Re: Auburn Road Clean Express Car Wash Site Plan Review #3

The Mannik Smith Group has revised the comments of the Site Plan for the Auburn Road Express Wash. We have the following responses:

C400 - Utility Plan

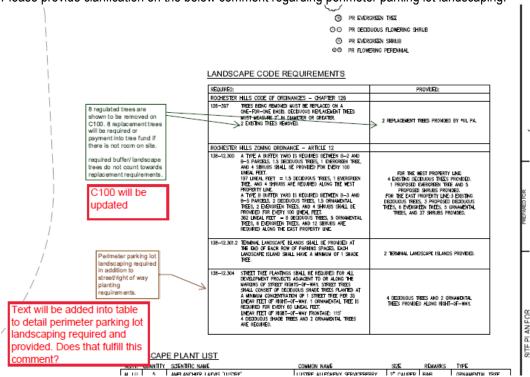
1. Proposed water main easement label removed.
